# SERVICE BULLETIN

**SER26-007**
**2/25/2026**

**SUBJECT: Lynx Fleet SROS Bracket**

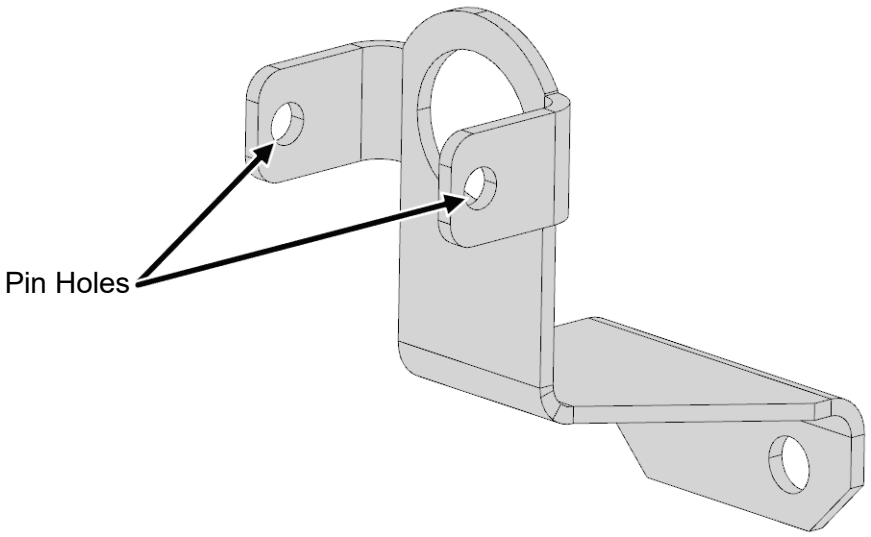
The pin holes on the SROS bracket that is used when the Power Control Switch (PCS) is installed may be too small and make installation of the pin difficult. If the pin is difficult to install, enlarge the pin holes using a #12 drill bit (0.189”).
